REDEVELOPMENT OF HARBOURSIDE SHOPPING CENTRE

SSD16_7874

Public Submission

1.1 Built form

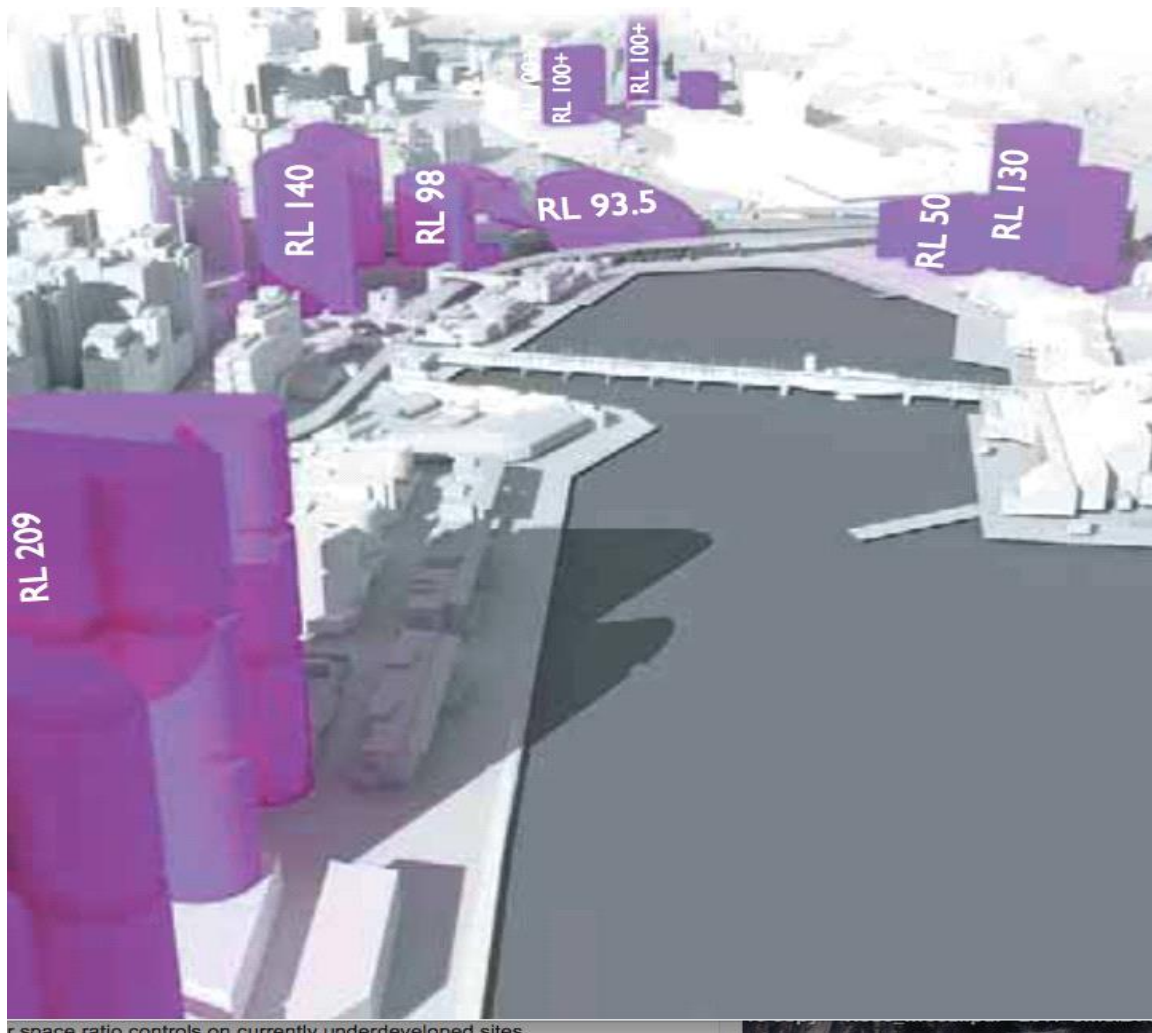
The proposal's is for a non-residential platform of varying RLs from 30.5 to 17.5. On top of this platform it is proposed to put several floor plates of residential at RL41.9, RL 54.5 and 74.5, before a further tower element to RL 166. In fact the proponent has a tower on a very large platform which a tower sits on; the tower is set back at RL30.5, again set back at RL41.9, again set back at RL54.5 and again set back at RL 74.5. To put this in context, the height at which the tower is set back at RL74.5 is well over the height of One Darling Harbour.

Very large floor plates at
RL41.9, RL54.5, RL 74.5

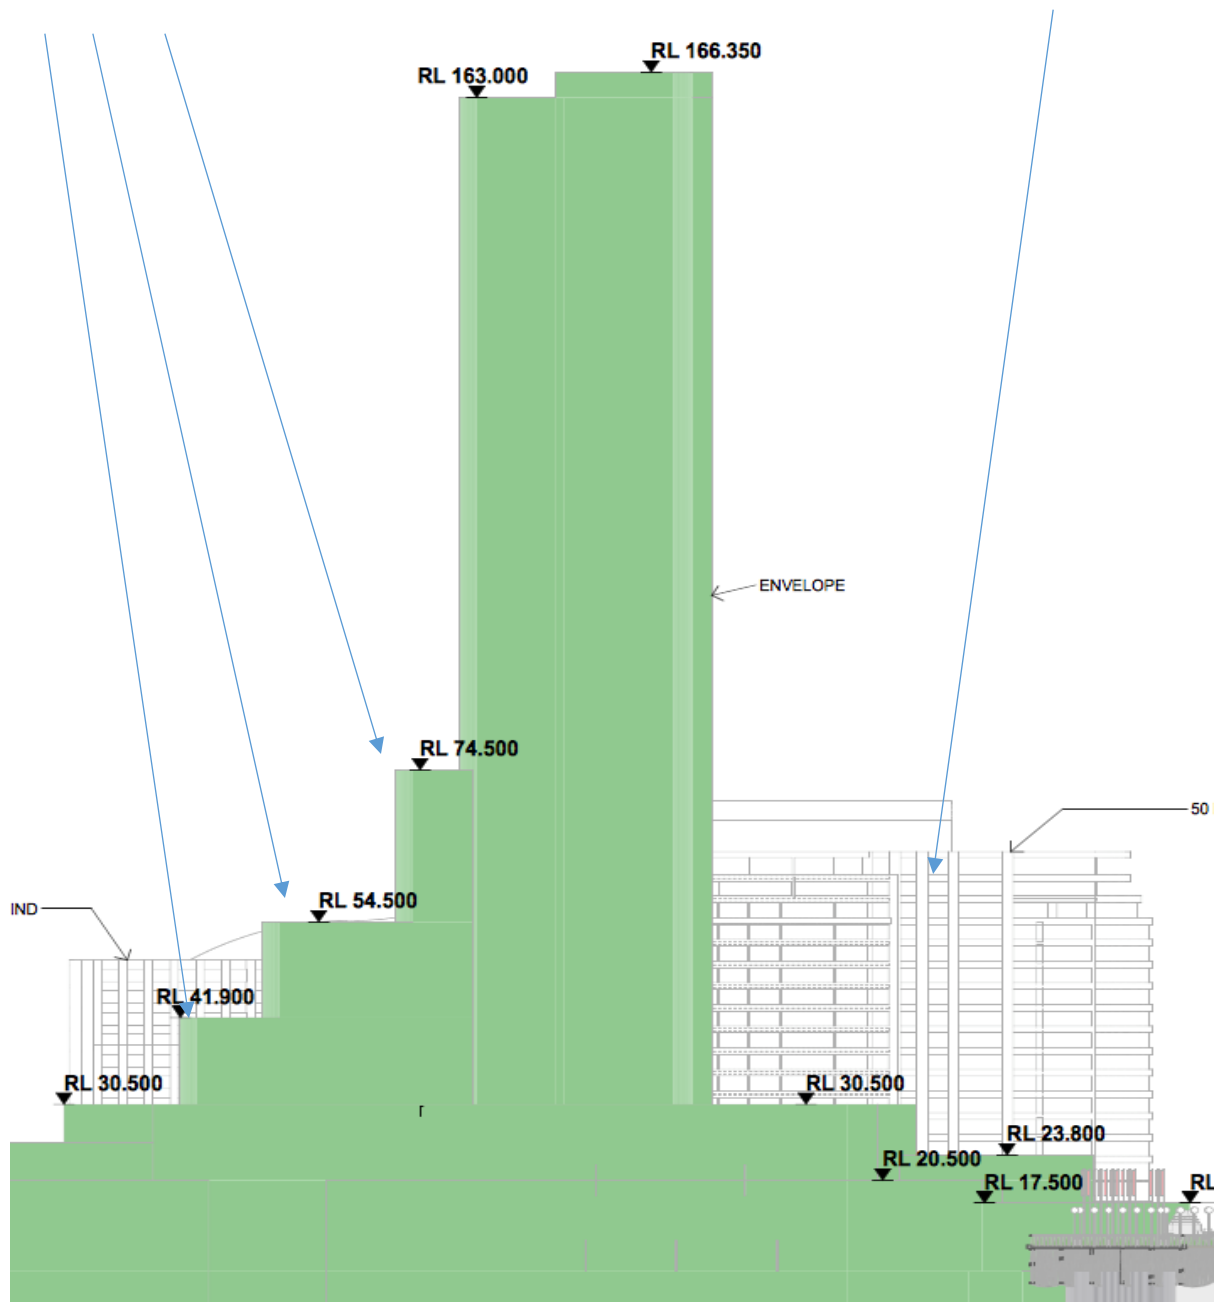
The bulk and scale of the tower in particular contrasts with the lower scale character of the Darling Harbour precinct and therefore is visually quite dominant and compromises and unsympathetic to the established valley floor character. The massive floor plates are totally unacceptable. The proponent states the floor plates are some 1,000sqm but this is at the top of the tower. They are massive floor plates lower down as the set backs take effect. This is a residential development and not a commercial commercial as before where floor plates of up to 1,200sqm are acceptable. The Department often quotes that residential towers should not exceed a floor plate of 600-800GBA and this should certainly be the limit in this sensitive area of Sydney.

I consider for these reasons The 'wings' of the tower element are not acceptable and should not be supported and the Tower floor plate above the shopping centre platform not exceed 800GBA with a maximum width of 25 meters.

Massing towards
Pymont Bridge

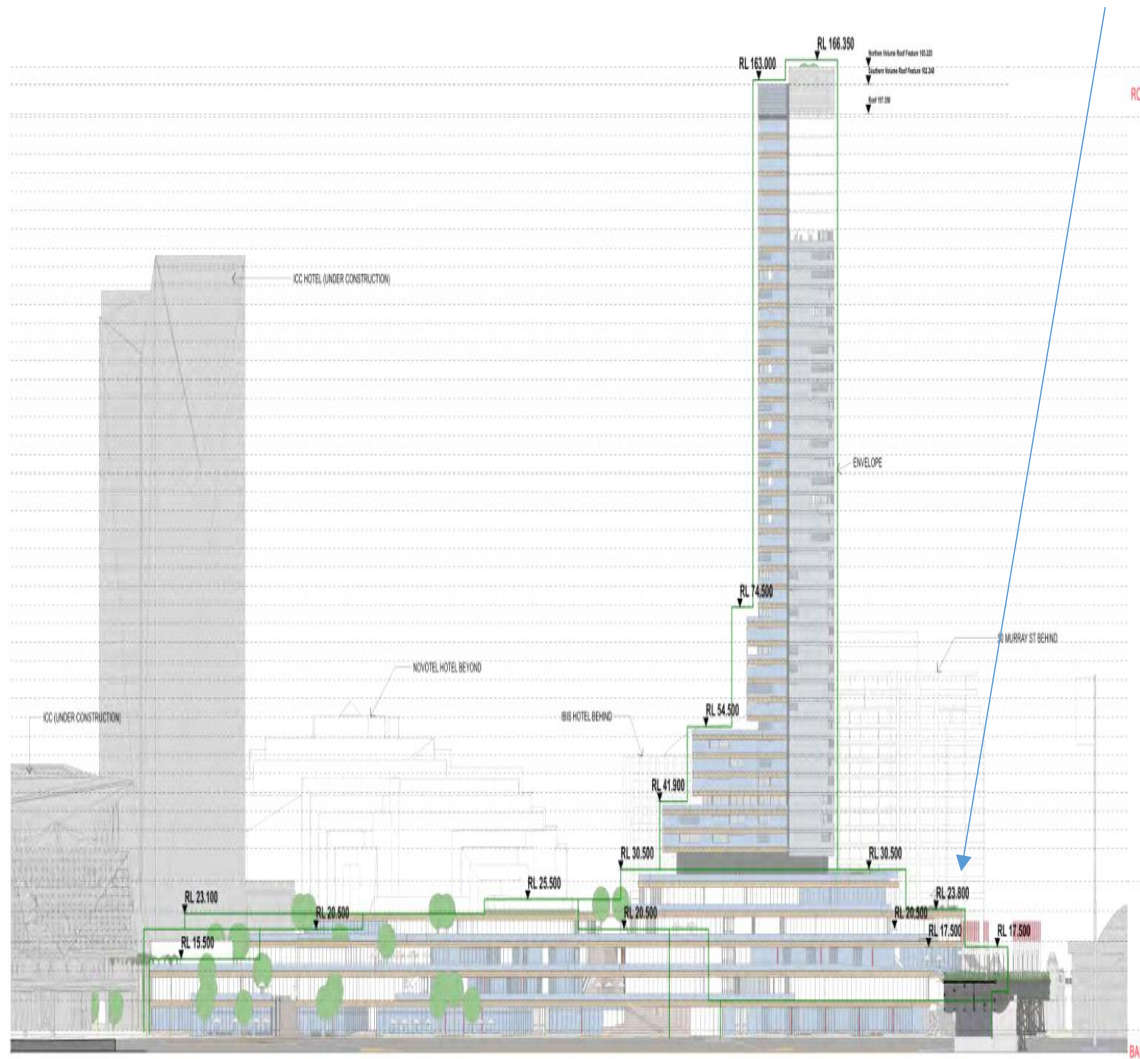
The height of southern section of the proposal is at RL 25. At the northern edge the RL climbs to RL 166 and declines with platforms at RL30.5 and RL23.8 some 10 meters from the heritage bridge.

The proposed massing across the site to the north is inconsistent with the proximity of the Heritage listed Pymont Bridge. The IMAX (RL50) defines the termination to the south of Cockle Bay and Pymont Bridge defines the termination of Cockle Bay to the north and the massing of the proposal towards the Bridge is inappropriate,

unsympathetic and overpowering. Particularly when the proponent offers the Central Tower option which will have far less impact on the heritage bridge allow the immediate setting of the bridge to be retained.

The proposed building will be one of the most visually dominant buildings surrounding Darling Harbour and will adversely impact on the current visual setting of the Pymont Bridge and will alter the setting of the Pymont Bridge, reducing the heritage significance of the bridge.

The Central Tower Option

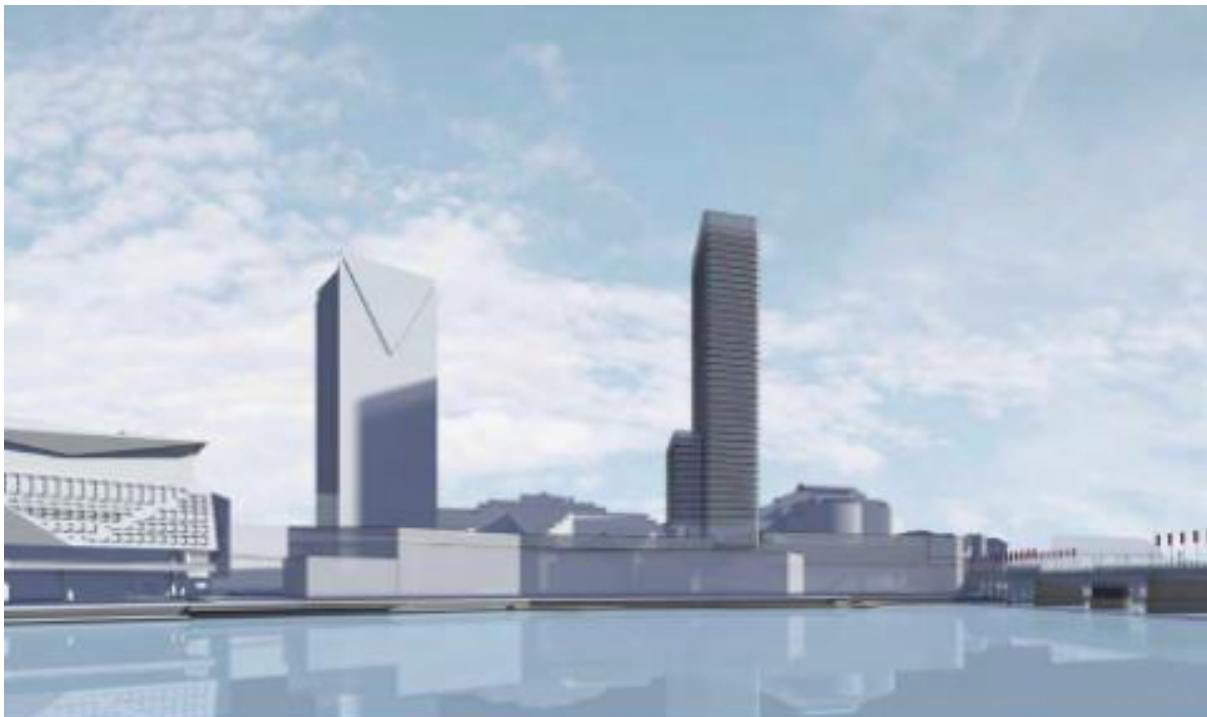
There is a significant gap between IBIS and Novotel hotels which aligns with east – west Bunn Street across from Murray Street. Placing the tower in this location which the proponent has identified as Central Tower addresses many of the environmental issues without reducing the development potential and amenity. This location allows view corridors for the Novotel Hotel, IBIS Hotel and One Darling Harbour. Second, it moves it further away from the heritage Pymont Bridge. By reducing the height it will

have no further impact on the public domain than the proposed option. It is a significant distance away from the IIC Hotel to cause privacy concerns.
